REGISTRY OF RADIOACTIVE SEALED SOURCES AND DEVICES
SAFETY EVALUATION OF DEVICE

NO: NR-474-S-107-S

SOURCE TYPE: Sealed Cobalt Source

MODEL: Drawing No. A200257

DIAGRAM:

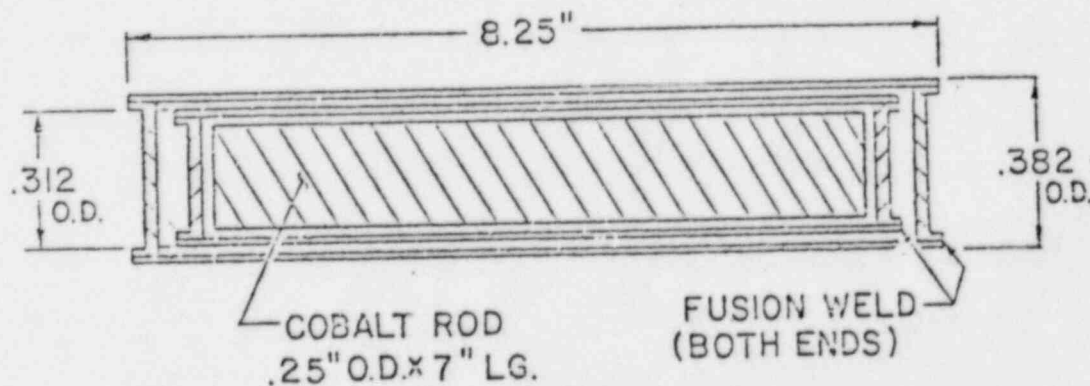
Based on our review of the information and test data cited below, we conclude that the Drawing No. A200257 sealed cobalt source design is compatible with a Gammacell 220 source design and thus is acceptable for custom licensing purposes. Furthermore, we conclude that the source would be expected to maintain its containment integrity for normal conditions of use and accidental conditions which might occur during uses specified in this certificate.
